ACCESSIBILITY AUDIT REPORT

MARINE DRIVE PROMENADE

NCPA TO MARINE DRIVE FLYOVER

DATE OF AUDIT: 22nd March 2021

1. Ramps and access ways to and from the promenade

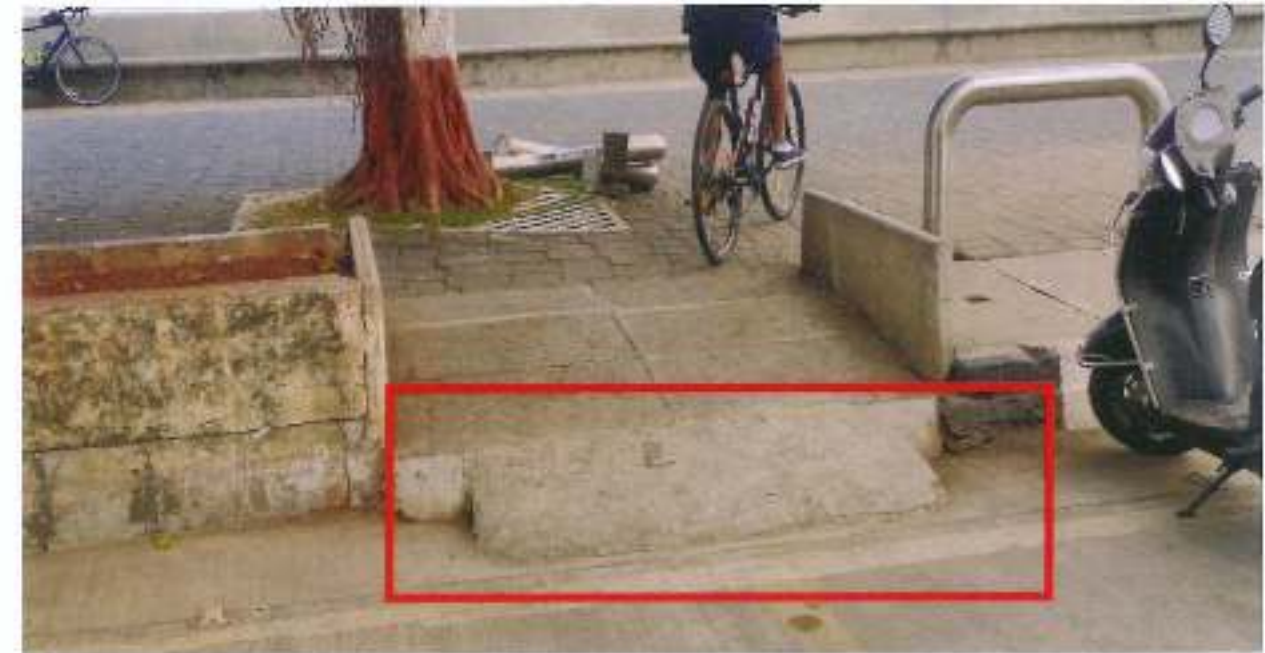
Kerb ramp present at the intersection has an efficient gradient but the road is at a higher level than the point at which the ramp starts. This makes a valley between the road and the promenade with a steeper slope from the end of ramp to the road making it difficult to negotiate.

The bollards placed at the center of the access way is the path of the wheelchair access.

Ramped accesses to the promenade are of an incorrect gradient.

2. Bus stops

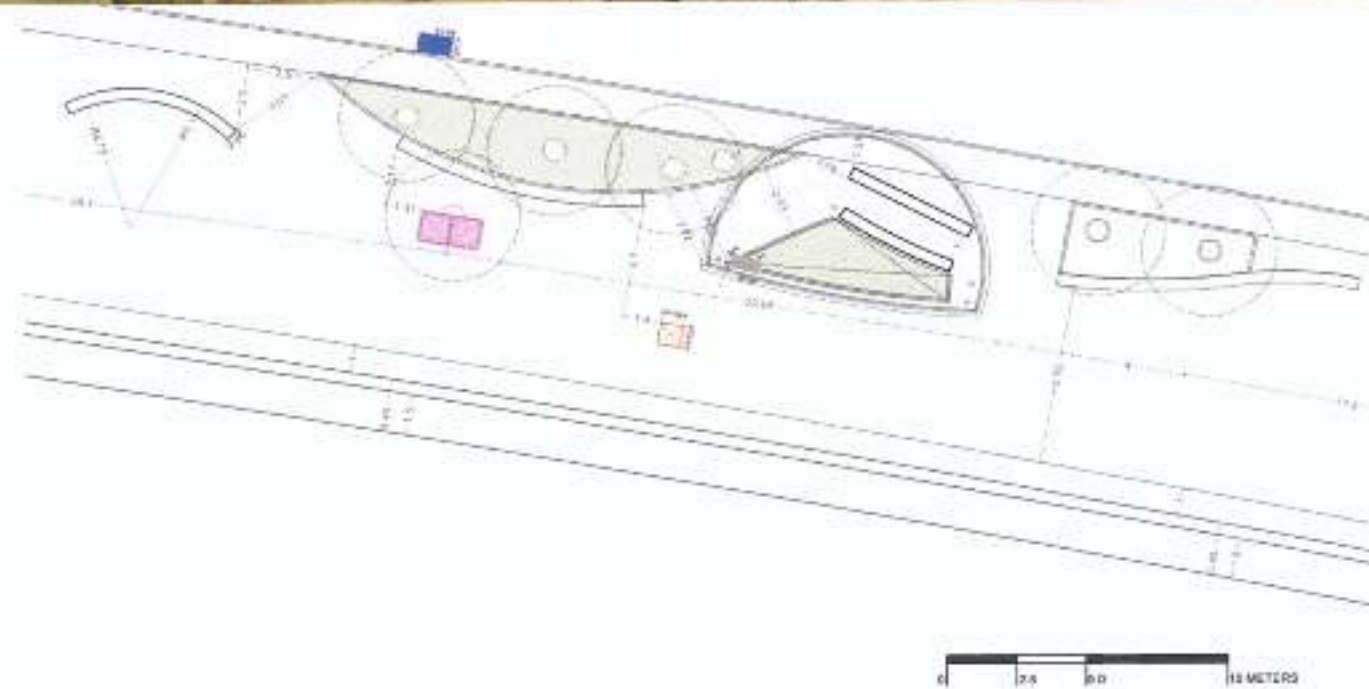
The road is at a lower level than the promenade and there is no ramped access to the road level from the bus stop for person to alight the bus. There is no dedicated wheelchair parking indicated at the bus stop.

The bus numbers are not readable and are not placed at an accessible height.

3. Newly installed bollards

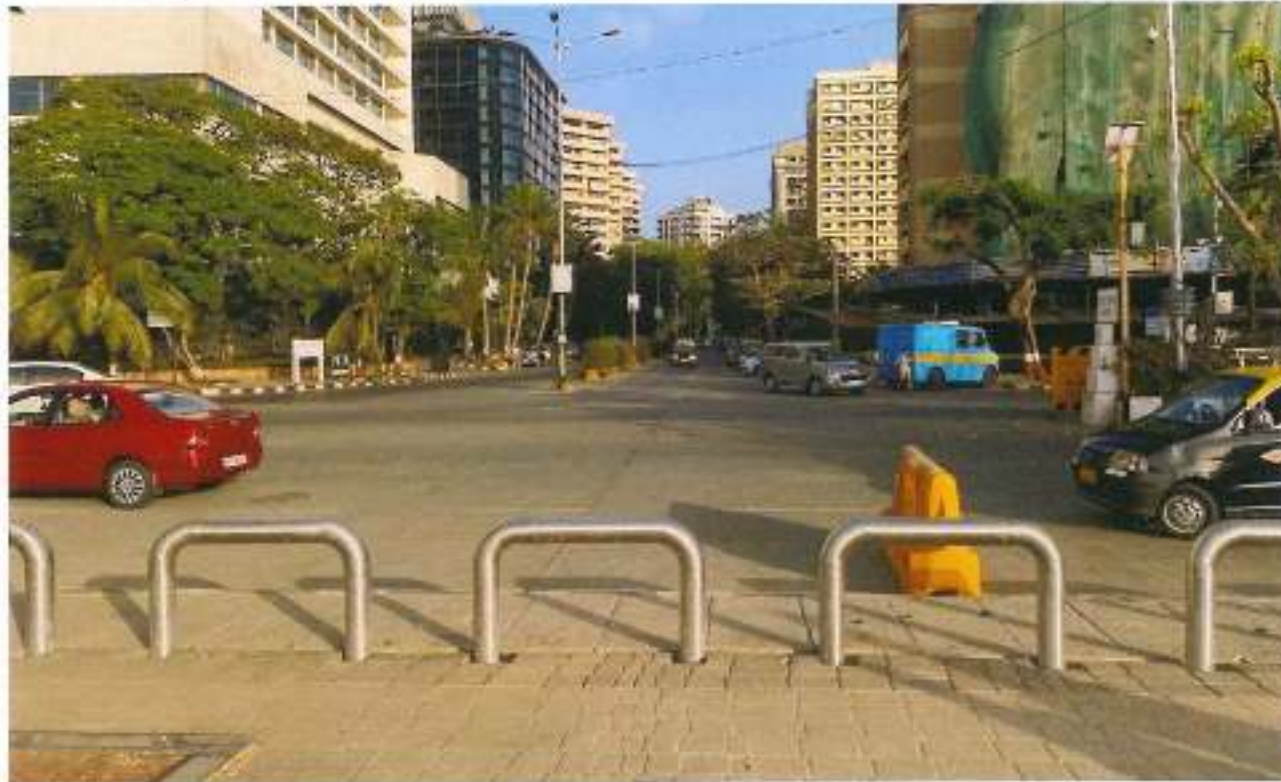
The newly installed bollards are 700 to 800 mm apart making them inaccessible for a wheelchair user. Minimum width required for a wheelchair to access a space is 900mm.

4. Tree gratings

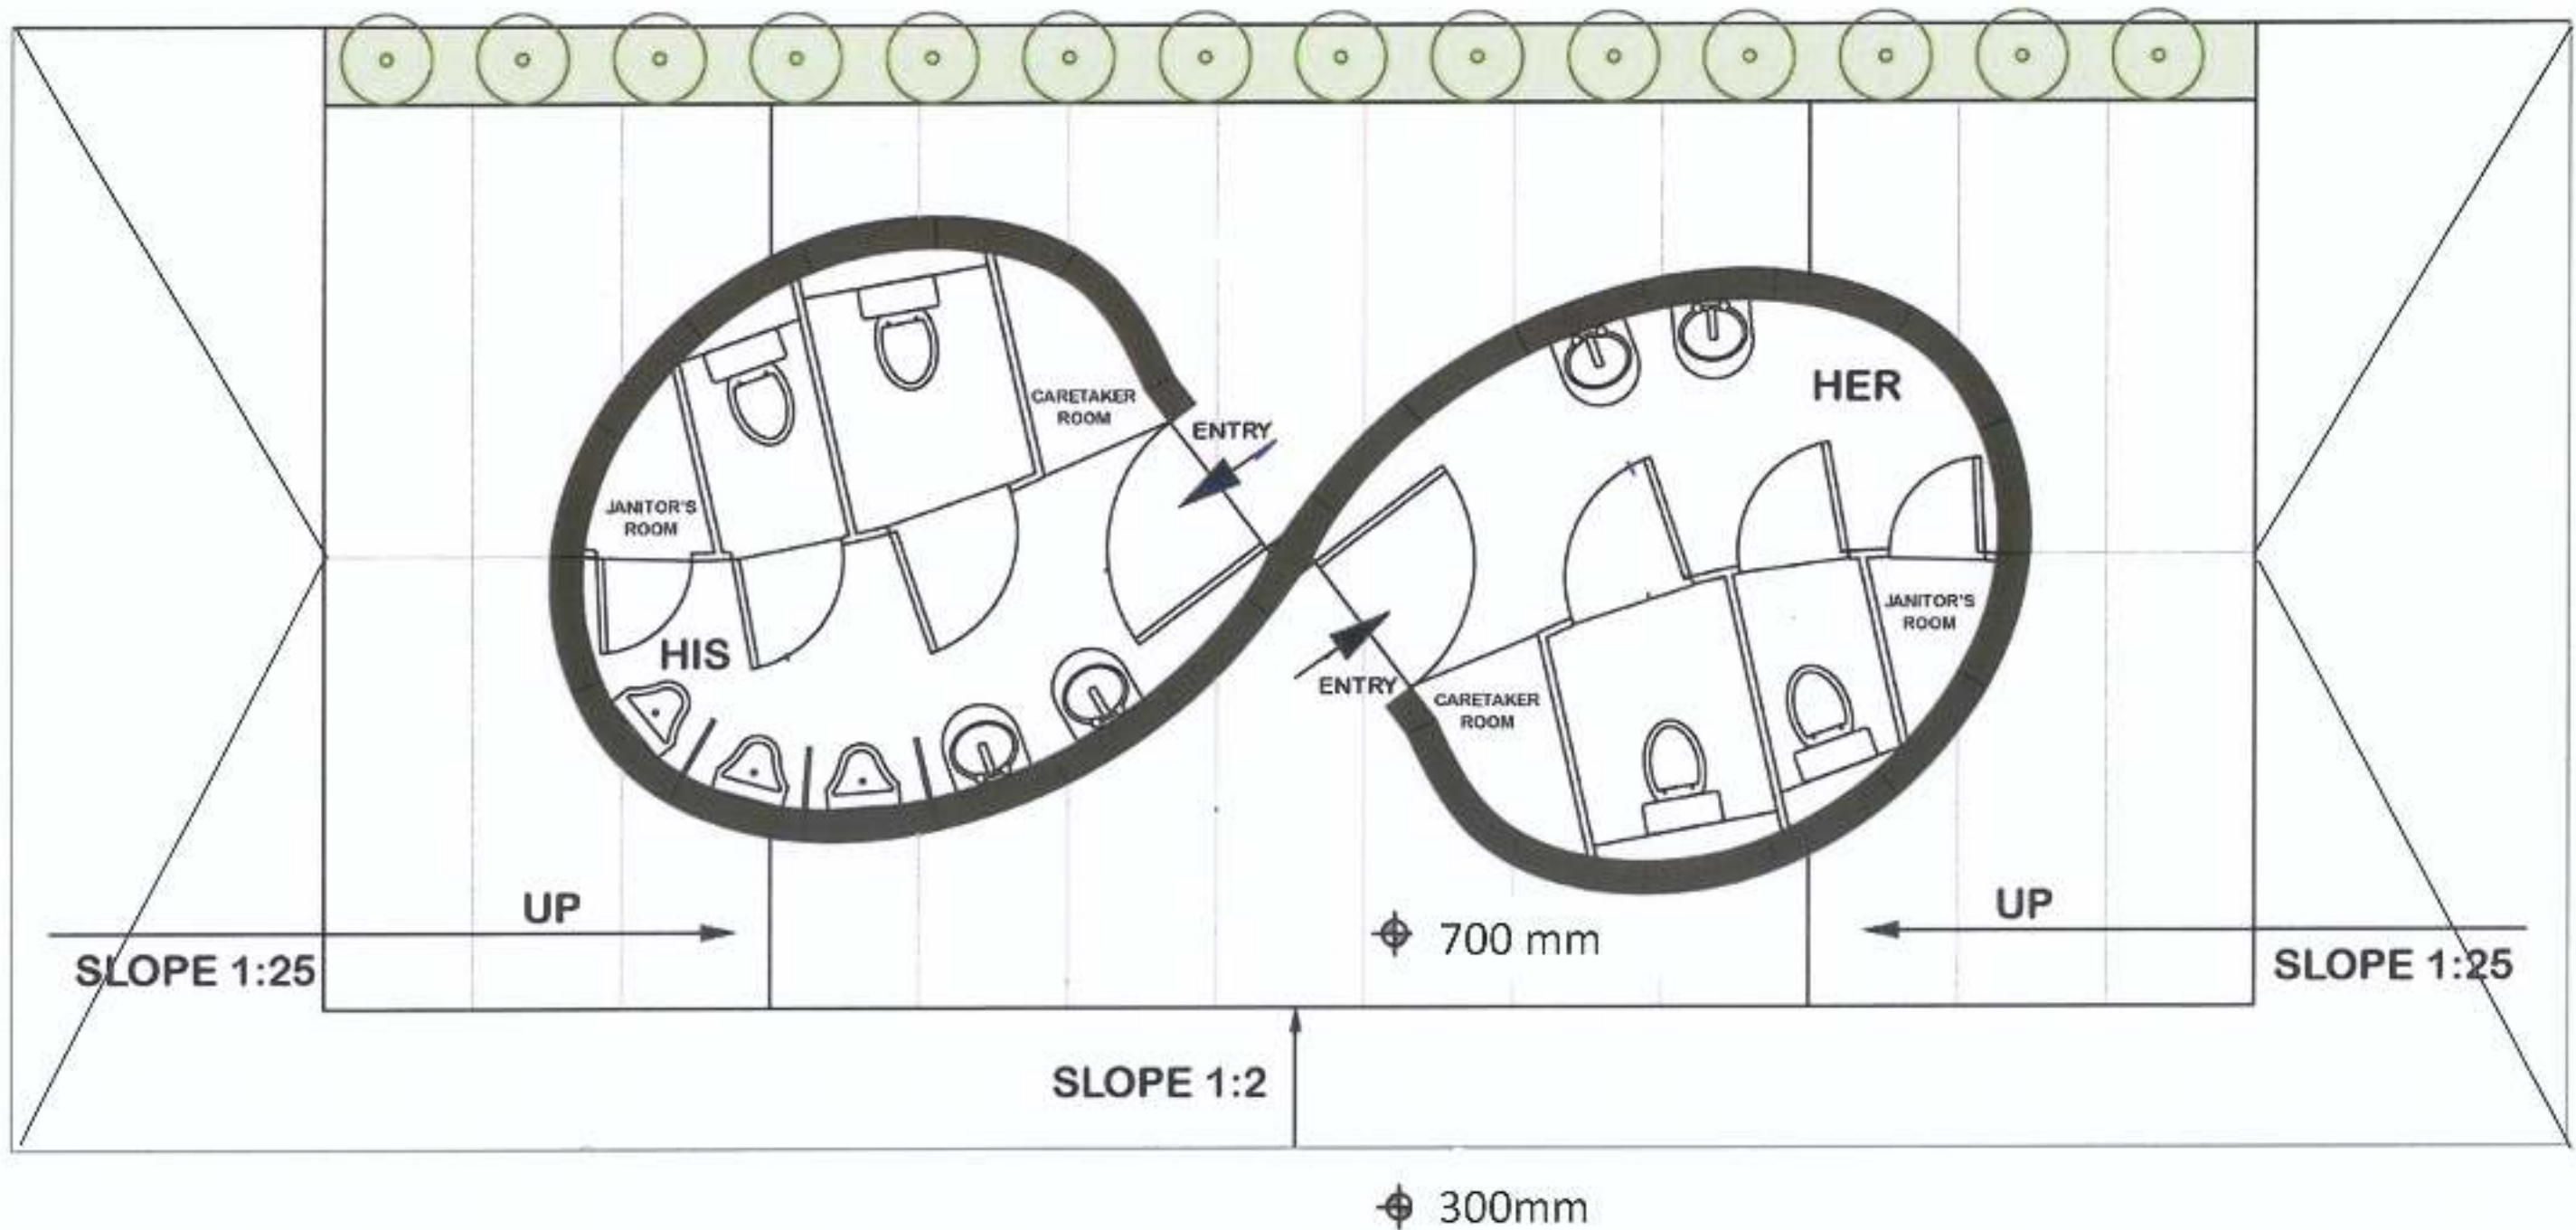
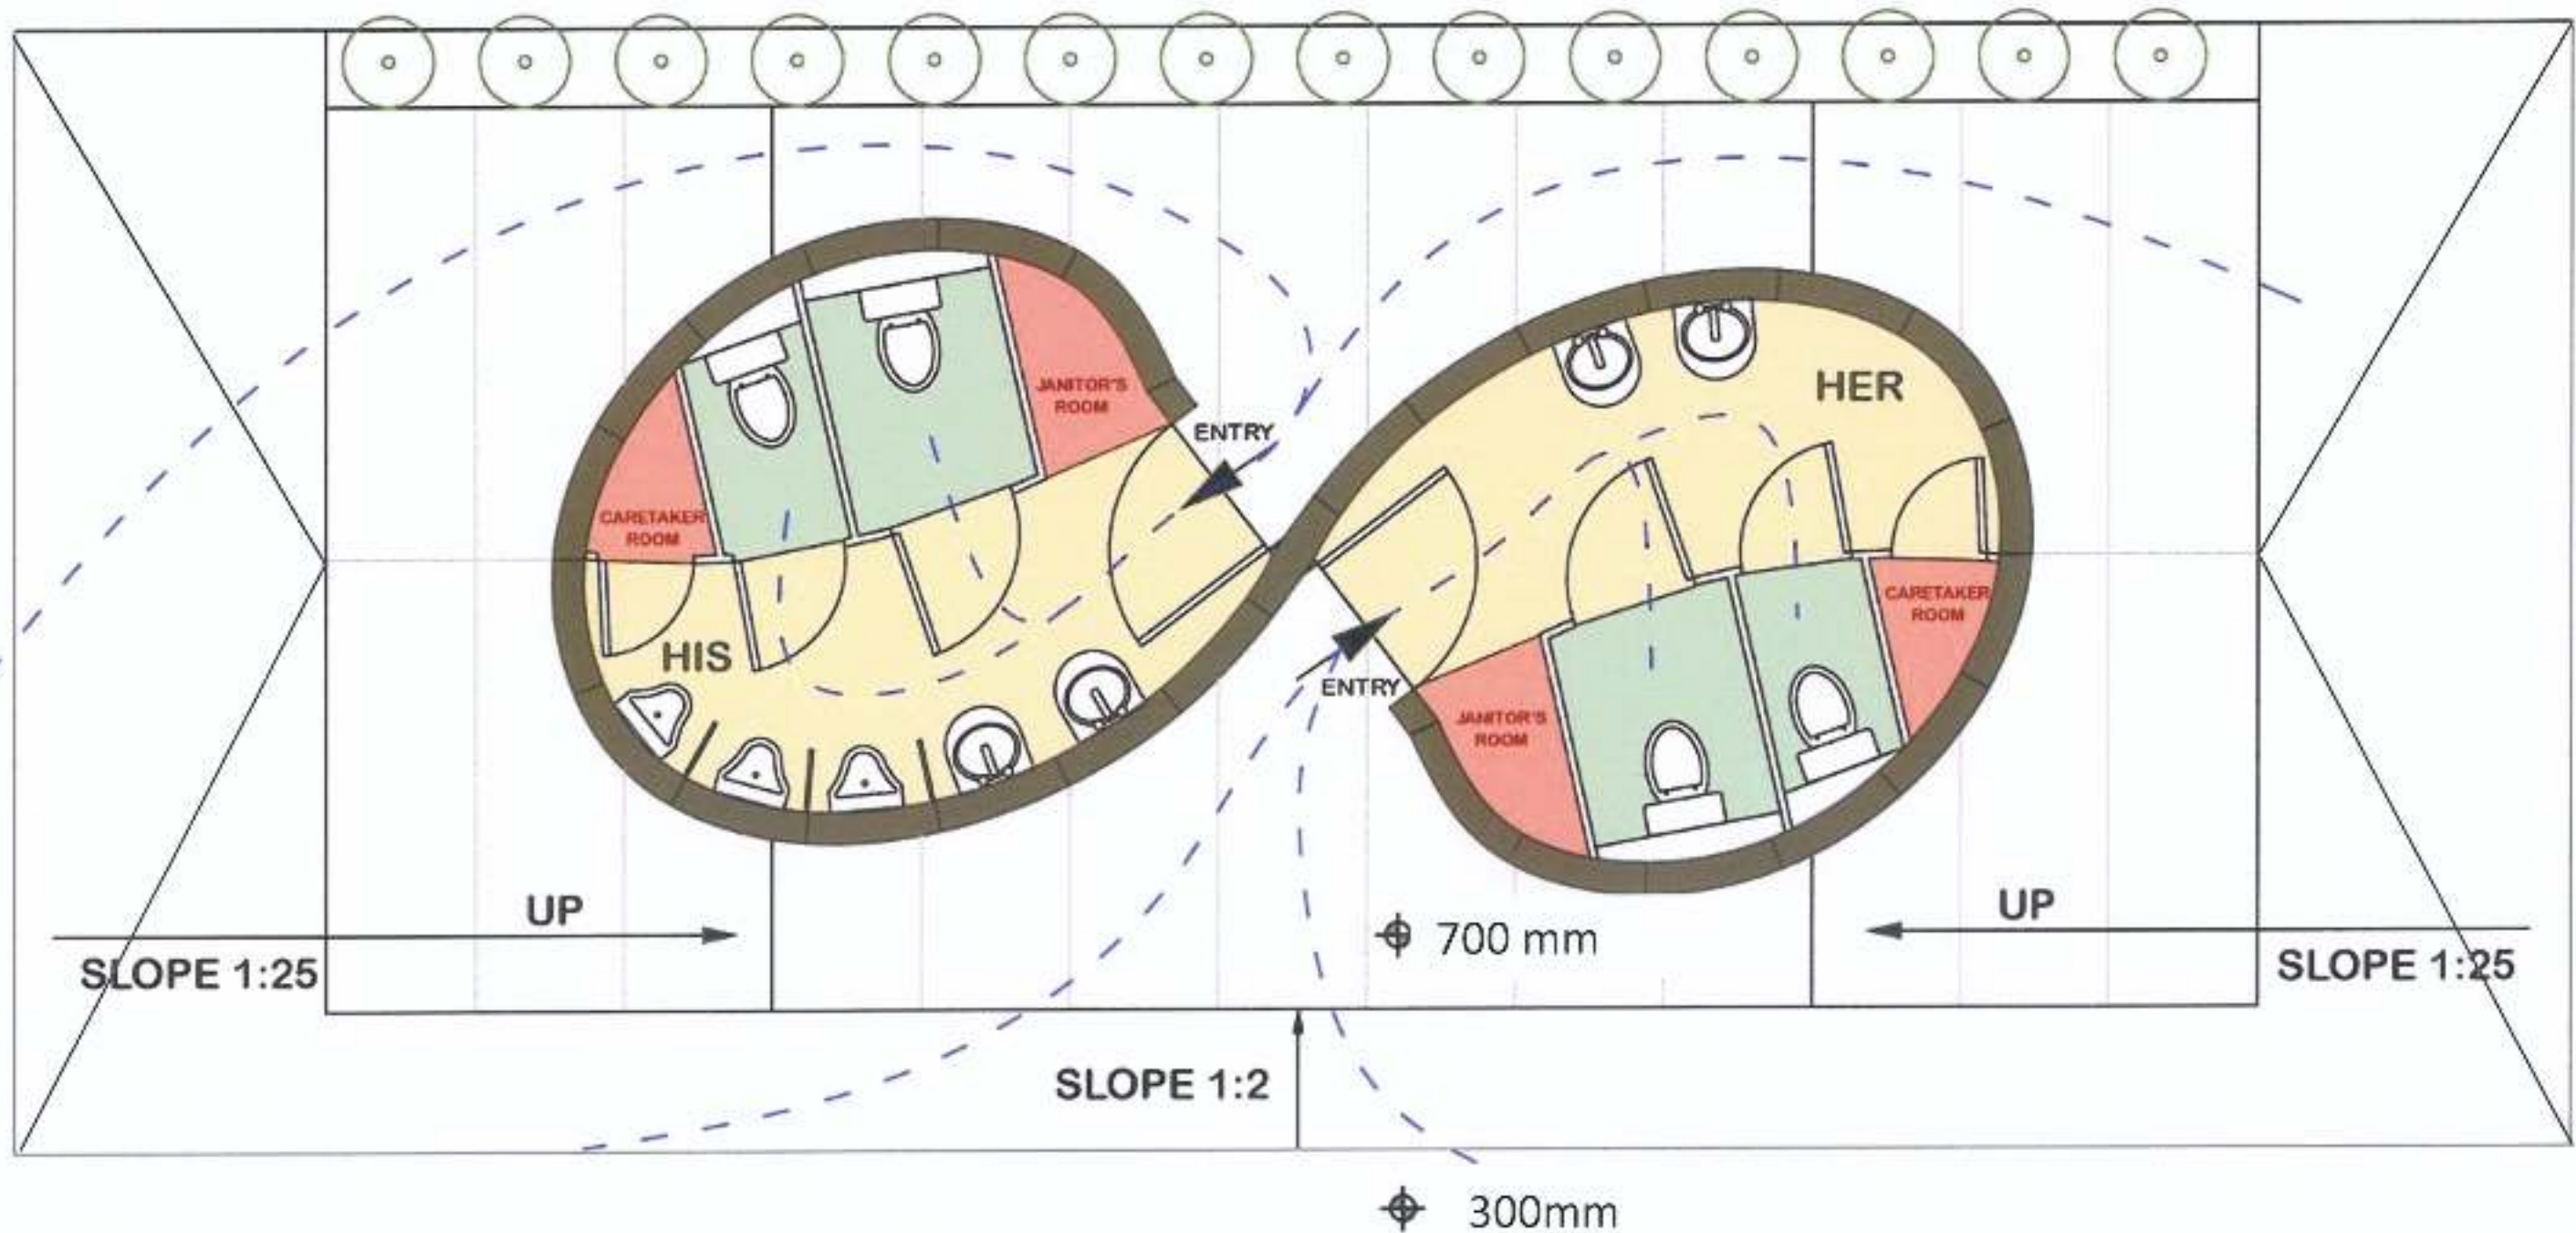
The growing roots of the trees resulting in broken grating and immediate paving. This creates an uneven surface making the area around the trees inaccessible for persons with disabilities.
